Public Comment No. 24-NFPA 72-2023 [Global Input]

Public Comment No. 22-NFPA 72-2023 [Section No. 1.4.1]

Figure 18.4.3.2 Temporal Pattern Parameters — Carbon Monoxide Signal.

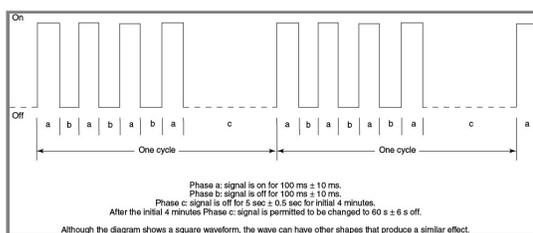
The existing Figure 18.4.3.2 does not reflect the text of 18.4.3.2(1) accurately. Specifically, the text reads: Signals shall be a pattern consisting of four cycles of 100 milliseconds \pm 10 percent "on" and 100 milliseconds \pm 10 percent "off", followed by 5 seconds \pm 10 percent "off", as demonstrated in Figure 18.4.3.2. The figure does not show 4 cycles of "on" and "off" followed by 5 seconds of "off", what the figure does show is 3 cycles of "on" and "off", followed by 100 milliseconds "on", followed by 5 seconds "off". The final 100 milliseconds "off" of the 4th cycle, before the 5 seconds "off", is missing from the figure. The attached image shows the missing 100 milliseconds "off" segment in red.

The existing Figure 18.4.3.2 does not reflect the text of 18.4.3.2(1) accurately. Specifically, the text reads:

Signals shall be a pattern consisting of four cycles of 100 milliseconds \pm 10 percent "on" and 100 milliseconds \pm 10 percent "off", followed by 5 seconds \pm 10 percent "off", as demonstrated in Figure 18.4.3.2.

Figure A.29.11.3.4(4)(d) Example of Exception Placement of Photoelectric Smoke Alarm or Smoke Detector at 72 in 6 ft . (1.83 m 8 m) from Stationary or Fixed Cooking Appliance.

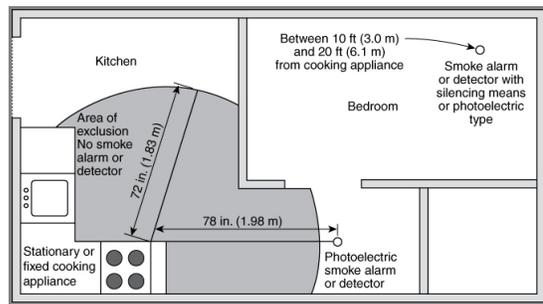
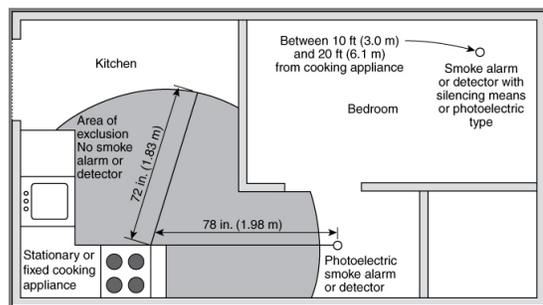
CHANGE FIGURE TO "SMOKE ALARM OR DETECTOR LISTED FOR RESISTANCE TO COMMON NUISANCE SOURCES FROM COOKING" IN BOTH LOCATIONS AND CHANGE "72 IN." TO "6 FT." AND "1.83 M" TO "1.8 M". ALSO CHANGE "78 IN." TO "6.5 FT" AND "1.98 M" TO "2.0 M"
